RE: SUB 2001-105 -- Final Plat of Gray's Fifth Addition

STAFF REPORT

CASE NUMBER: SUB 2001-105 -- GRAY'S FIFTH ADDITION

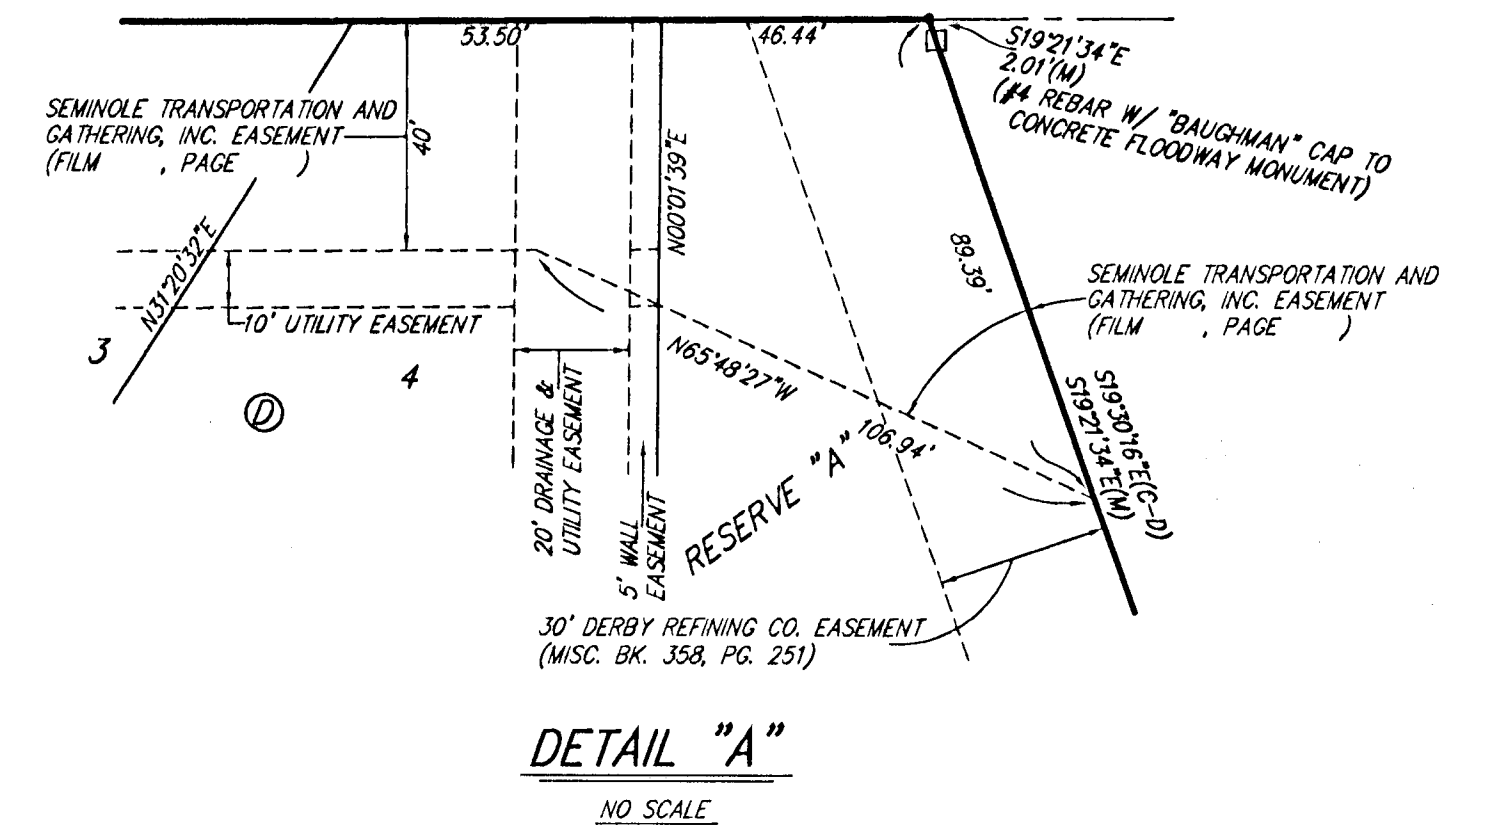
- C. The Applicant shall guarantee the extension of City water and sanitary sewer to serve the lots being platted.
- D. City Engineering needs to comment on the need for any guarantees or easements. The Applicant shall submit a revised drainage plan. A drainage guarantee is needed.

- E. County Engineering needs to comment on the need for street improvements. County Engineering has requested a guarantee for a sidewalk and signalized pedestrian crossing along Hoover Road; however actual construction will be based on traffic warrants. Left turn lanes are required along Hoover.

- F. **County/City Engineering** needs to comment on the status of the applicant's drainage plan. **A Drainage Plan and Master Lot Grading Plan is needed. A Levee permit from County Engineering is required for the pond construction in Reserve A. The Soil Conservation District should be contacted regarding elimination of the terraces.**

- G. **County Fire Department** requests a temporary 20-ft access road adjacent to the plat on the south line from Hoover to Doris. **The Applicant shall reach an agreement with the County Fire Department on this issue prior to City Council consideration.**

- H. **GIS** has requested that abbreviations be used to label the street suffixes (44th St. S).
- I. Provisions shall be made for ownership and maintenance of the proposed reserves. The applicant shall either form a lot owners' association prior to recording the plat or shall submit a covenant stating when the association will be formed, when the reserves will be deeded to the association and who is to own and maintain the reserves prior to the association taking over those responsibilities.

- N. On the final plat, the MAPC signature block needs to reference "J.D. Michaelis, Chair".
- O. The applicant shall submit a copy of the instrument which establishes the pipeline easements on the property, which verifies that the easements shown are sufficient and that utilities may be located adjacent to and within the easements.

- P. The applicant's agent shall determine any setback requirements for the pipelines by researching the text of the pipeline agreements. If a setback from the pipeline easements is provided for in the pipeline easement agreements, it shall be indicated on the face of the plat.

- Q. The Subdivision regulations discourage the inclusion of pipeline easements within the perimeter of residential lots. It is recommended that the pipeline crossing the northern line of the plat be included within a Reserve, or in the alternative a restrictive covenant provided identifying the pipeline easement. southbound left turn lane. *The Applicant intends to retain the pipeline easements on the lots. A restrictive covenant will be needed.*

- Z. The representatives from the utility companies should be prepared to comment on the need for any additional utility easements to be platted on this property. *KGE has requested additional easements.*
